BULLETIN

Bulletin No. 103

SUBJECT: Shock Strut Stop Discs

TO: Owners of J3 Series Airplanes Incorporating Landing Gear Approved For 1220 Lbs. Gross Weight and PA-11 Airplanes Serial Nos. 11-1 to 11-352 incl., 11-354 to 11-357 incl., 11-359, 11-361 to 11-369 incl., 11-371 to 11-375 incl., 11-377 to 11-385 incl., 11-387, 11-396 to 11-402 incl., 11-413, 11-414 and 11-430, also 11-1354 to 11-1474 incl.

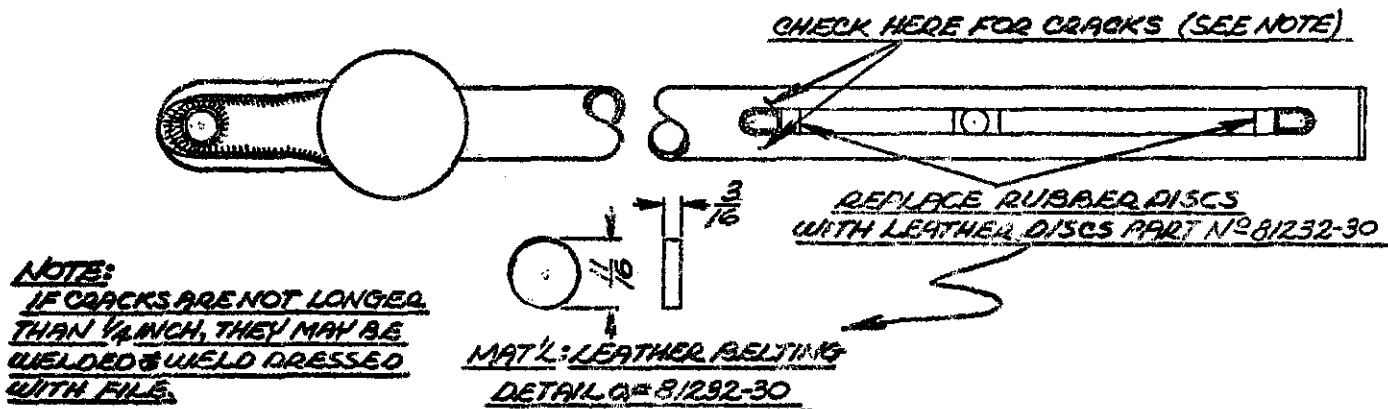
The shock struts of the above listed airplanes incorporate rubber stop discs (Part No. 81232-13) at the ends of the stop bolt slots.

As these rubber discs require frequent replacement in service, and, in some cases, have caused deforming and cracking of the strut tube, it is recommended that they be replaced with leather discs (Part No. 81232-30) at the next periodic inspection, or when maintenance of the landing gear is necessary.

Parts 81232-30 are available from your Piper distributor, or may be made from belting leather.
